AMENDMENT(S) TO THE DRAWINGS

REMARKS

Claims 1 and 2 are pending and rejected in this application. Claim 1 is amended hereby.

Fig. 1

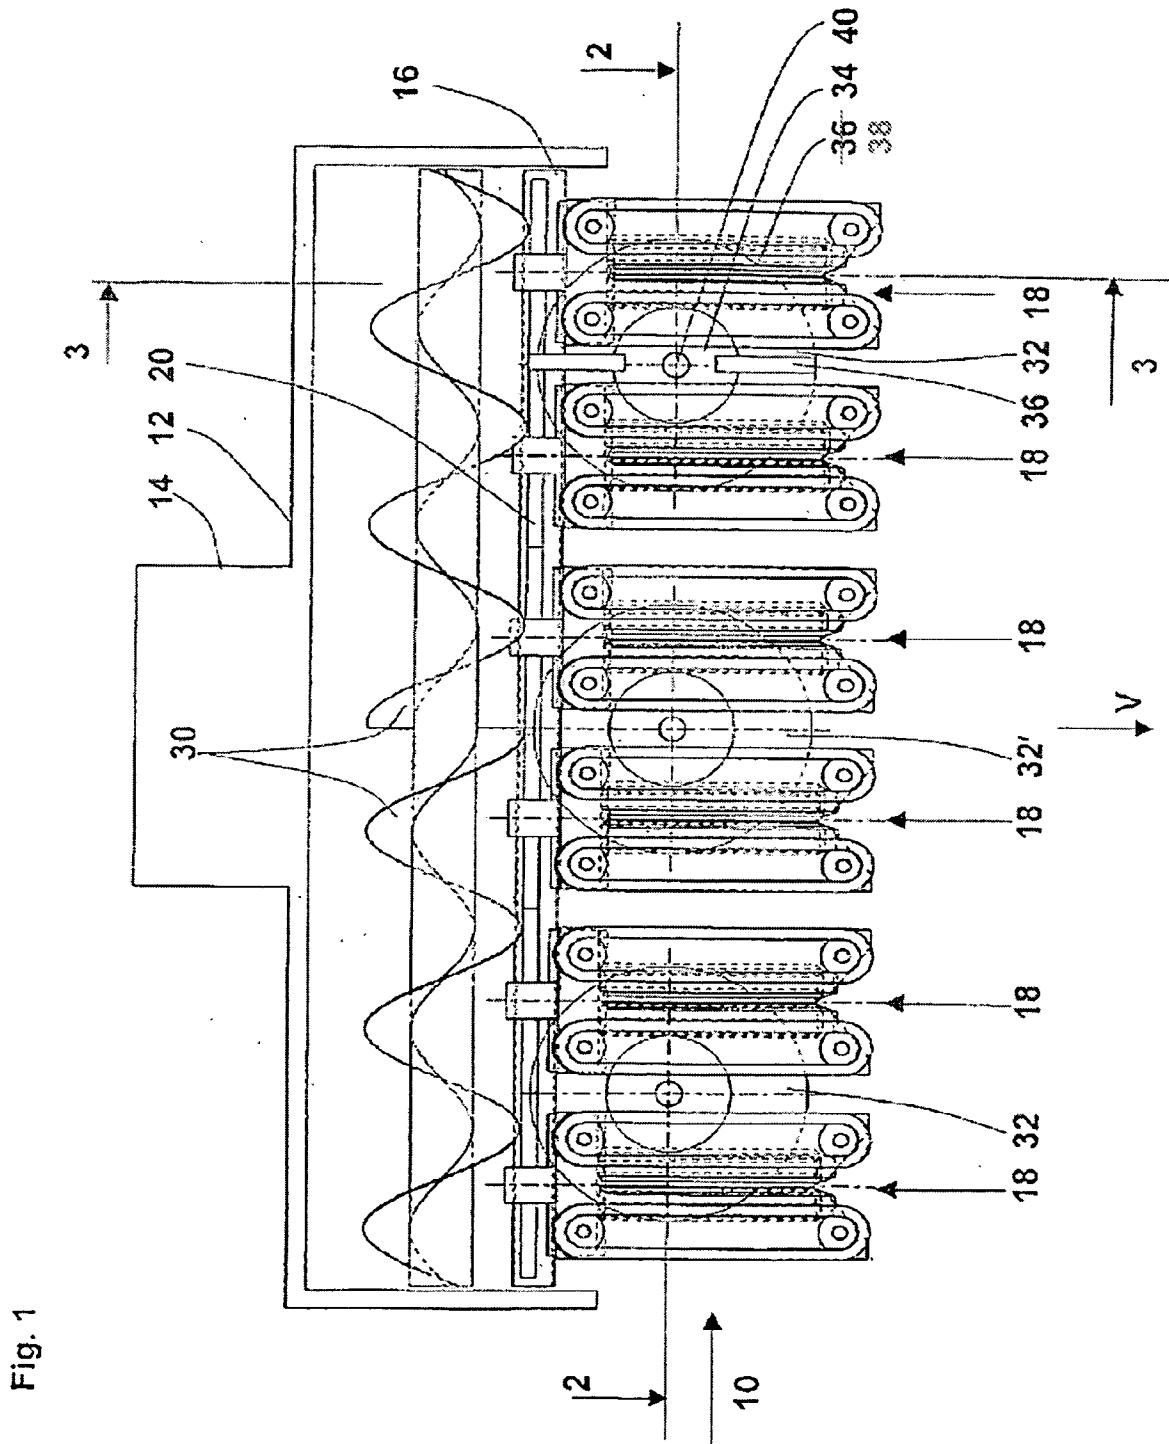
Responsive to the objection to the drawings, Applicant has amended Fig. 1 and has corrected the drawing to properly note and identify the envelope circles 38. Accordingly, Applicant submits that the drawings are now in allowable form, and do hereby respectfully request the withdrawal of the objection thereto.

The Abstract has been objected to because reference numeral 38 was not provided in the drawings. The drawing corrections discussed in the preceding paragraph have addressed this issue. Accordingly, Applicant submits that the Abstract is now in allowable form and respectfully requests that the objection be withdrawn.

Please amend Fig. 1 as indicated in red on the attached Annotated Sheet. A Replacement Sheet presenting replacement figures which incorporate the desired changes is also enclosed in the Submitted Drawings section of this amendment.
